Aftertreatment Diesel Exhaust Fluid (DEF) Tank, Level Sensor, Replacement

M-258-012

(Aug 2023)

All Mack MMD Trucks

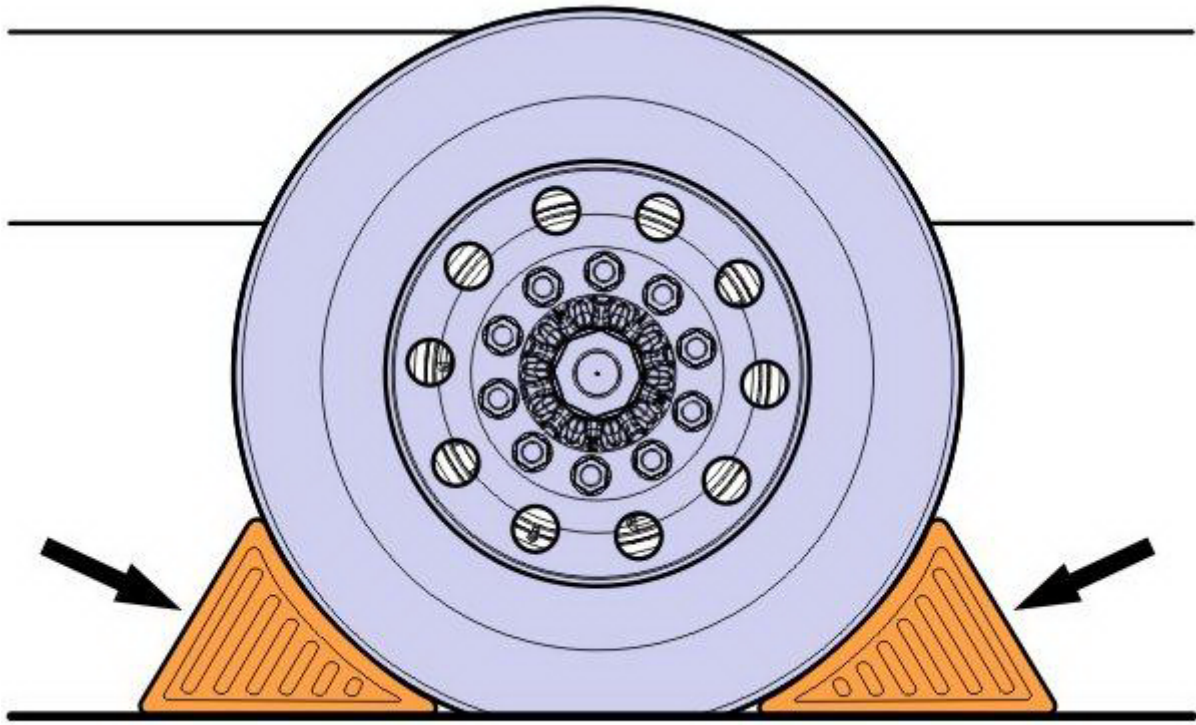
Mack trucks now offer an updated UQLS to improve functionality and reliability. The new sensor will be a direct replace except for a jumper harness used to plug the new sensor to the existing chassis harness connector. Follow the instructions below to install the new UQLS and its jumper harness.

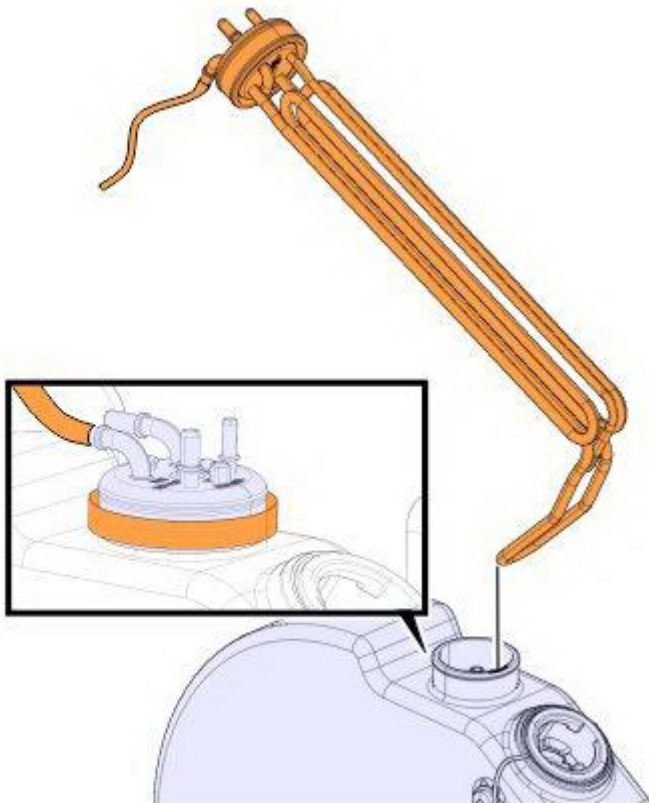
- 31. Install the new sensor **24015866**.

Note: The new UQLS sensor no longer uses the external module and requires a jumper harness.

32. Install the clamp and torque to specifications.

Tightening torque	
Tank, clamp	3 Nm

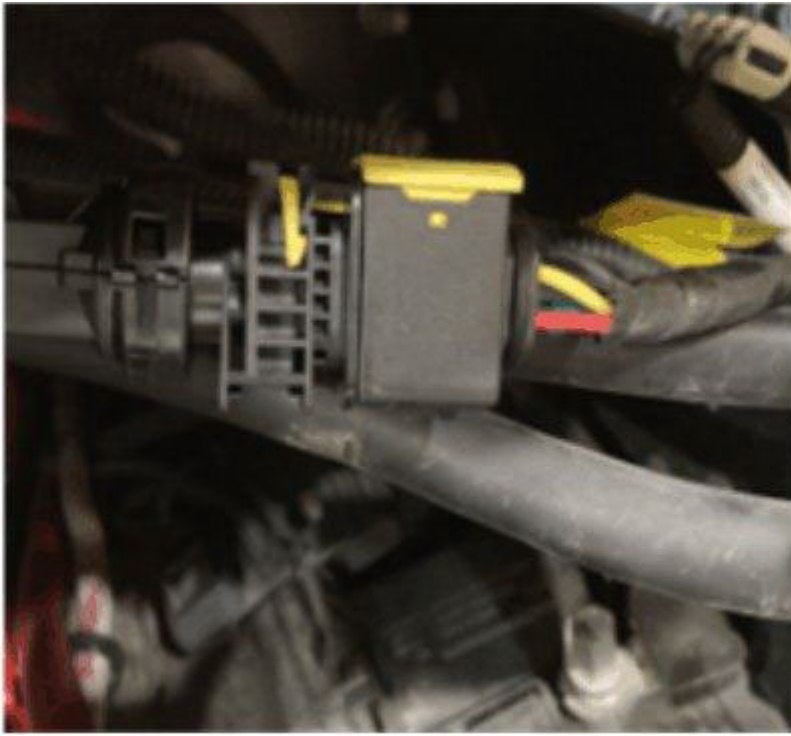
38. Connect the jumper harness 24399920 to the chassis harness and the new sensor.
